ADDENDUM NO. 1

CANNONBALL PATH PHASE 5

CONTRACT NO. 7238

STEEL CASING PIPE FOR E80 LOADING	
MIN. THK. (IN.) FOR PIPE NOT CATHODICALLY PROTECTED	CASING PIPE DIAMETER (IN.)
0.3750	18 - 22
0.4375	22 - 25
0.5000	25 - 34
0.5625	34 - 42
0.6250	42 - 48

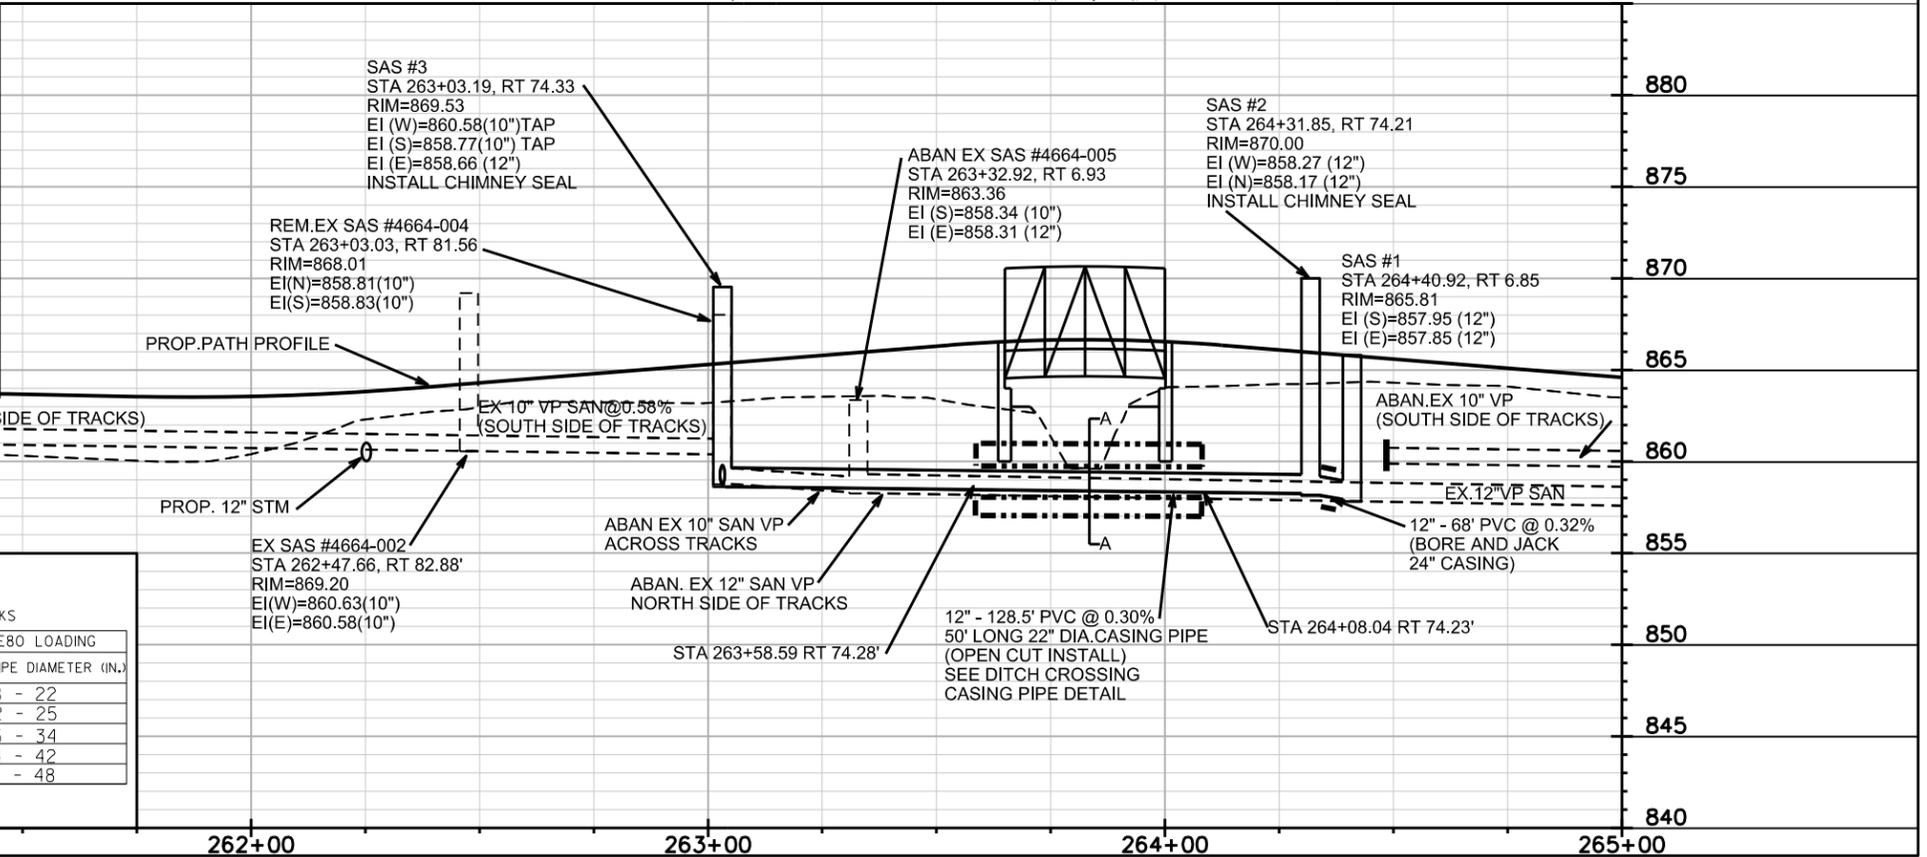
REMOVE SHEET U-1

INSERT SHEET U-1 (Revised 6/17/14)

Delete "0.4375" minimum thickness (See chart on Sheet U-1 for casing thickness requirements)"

Replace with "0.375" minimum thickness"
